CONSTRUCTION SUMMARY
Legacy Hill - Trinigroup Development Inc.

LOT / PHASE 31 / 1	REG. PLAN #	HOUSE TYPE Rose 6 Elev 3 (5 Bedroom)		
-----------------------	-------------	---	--	--

Rose 6 40' Lot

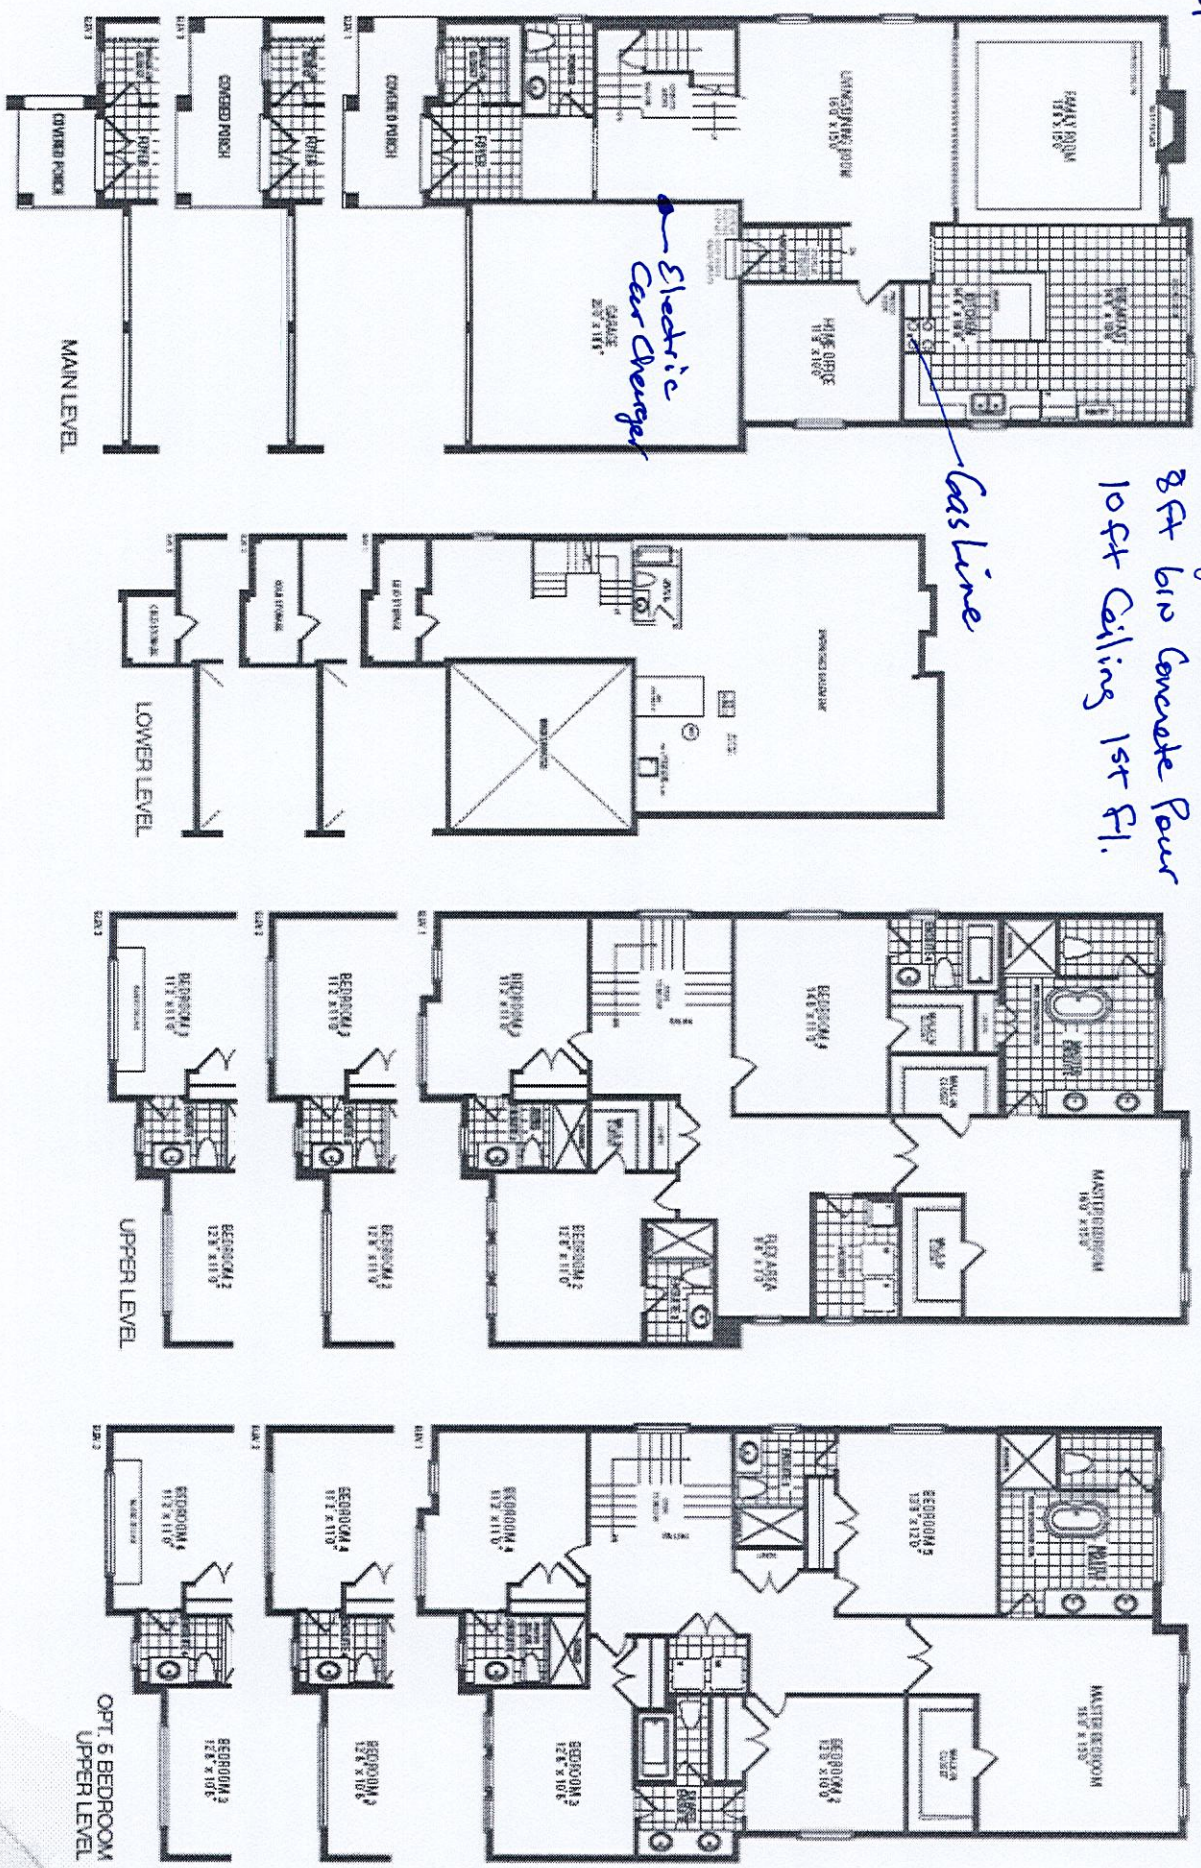
2 - ENLARGED BASEMENT WINDOWS (MAY REQUIRE WINDOW WELLS) - WINDOW IS 30 INCHES X 24 INCHES 25Oct23 Note:	
1 - LOWER LEVEL - BASEMENT 8 FOOT 6 INCH CONCRETE POUR - MEASURED FROM TOP OF FOOTING TO TOP OF FOUNDATION WALL 25Oct23 Note:	
1 - FIRST FLOOR INCREASE CEILING HEIGHT FROM 9 FEET TO 10 FEET 25Oct23 Note:

Enlarge Basement Windows
8 ft bio Concrete Pour
10 ft Ceiling 1st Fl.
